# LYNDALE APARTMENTS

PL202500176
PL2025-176

# DRAFT SITE PLAN

# SITE

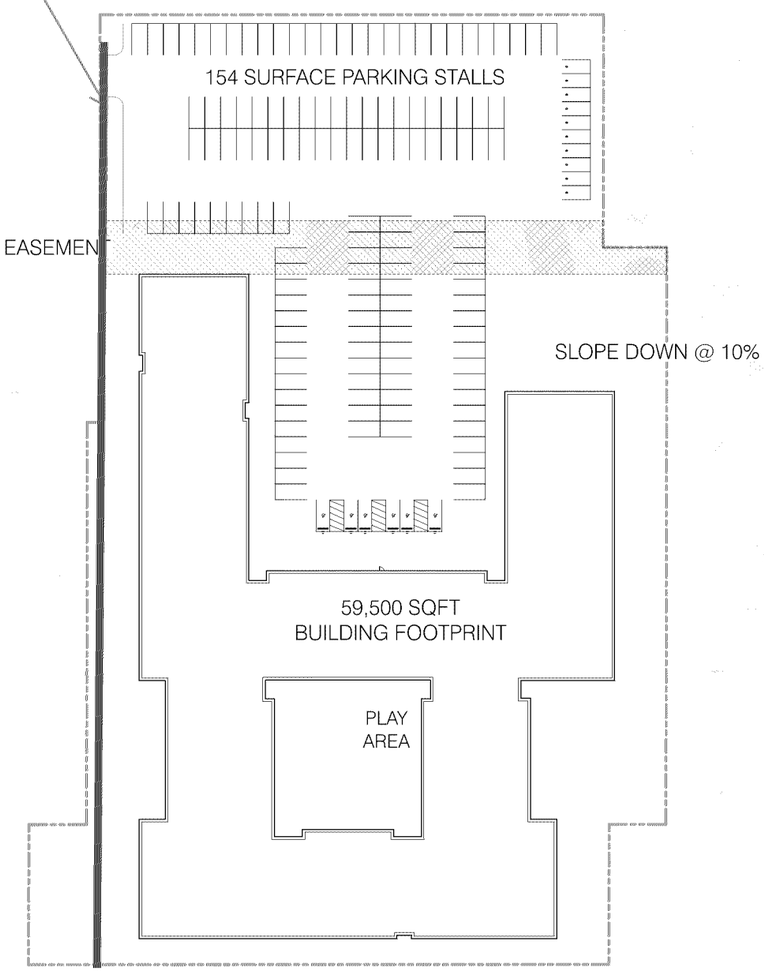
Incorporate a 20-foot landscape yard between Lyndale Avenue and surface parking lot.

8-foot concrete sidewalk must be installed along Lyndale Avenue S. Also provide a sidewalk connection from public sidewalk to main entrance.

Must meet 2020 MN State Building Code

Must meet 2020 MN Accessibility Code.

Provide a detailed code analysis with the plans.

Building plans must be signed by a MN licensed architect.

When plans are 80% complete please contact Building & Inspections to set up a Building Code review.

Must meet 2024 MN Energy Code and any testing/commissioning requirements.

SAC review by MET council will be required.

On January 2nd, 2025, the City of Bloomington implemented a City SAC charge. The cost will be $2,026 per City SAC unit. The amount of SAC charged will mirror the MET Council Determination. This applies to any permits submitted on or after 01/02/25.

All emergency vehicle access lanes including all areas of the parking structure (top and lower levels) shall support a minimum 40 tons.

All exterior doors that allow access to the interior of the building(s) shall be numbered in a sequential order starting with the main entrance (public entrance) as number 1 and continue in a clockwise manner.

A looped water supply feeding a single, combined water service is required for the domestic and sprinkler system water demand.

Standpipes requirement in all stairwells and hose valves shall be located at the floor landing.

Building/property shall be adequately signed for emergency response.

Emergency responder radio coverage meeting the requirements of appendix P in the 2020 MSFC shall be provided throughout the property and within the structures.

Lack of emergency vehicle access is a concern.

Hydrant coverage shall be provided within 50' of the FDC and within 150' of all portions of the structure.

Entire space(s) shall have fully complying sprinkler protection.

Hose valves shall be provided throughout the lower level of the parking garage within 130' of all areas of the garage if dry standpipe or within 200 feet if installing a wet standpipe

# LEVEL 1

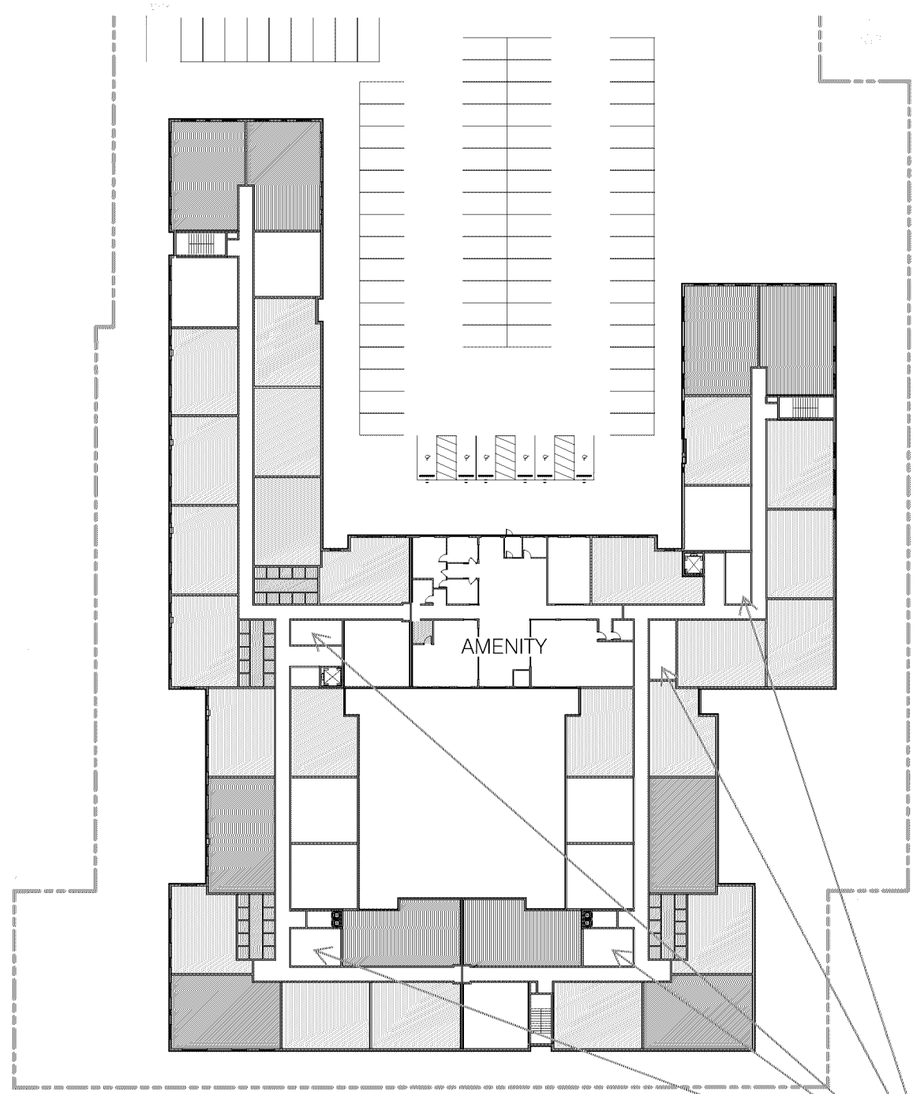
Are these spaces tenant storage spaces?
Please identify the dimensions and quantity
of storage units in order to review for code
compliance.
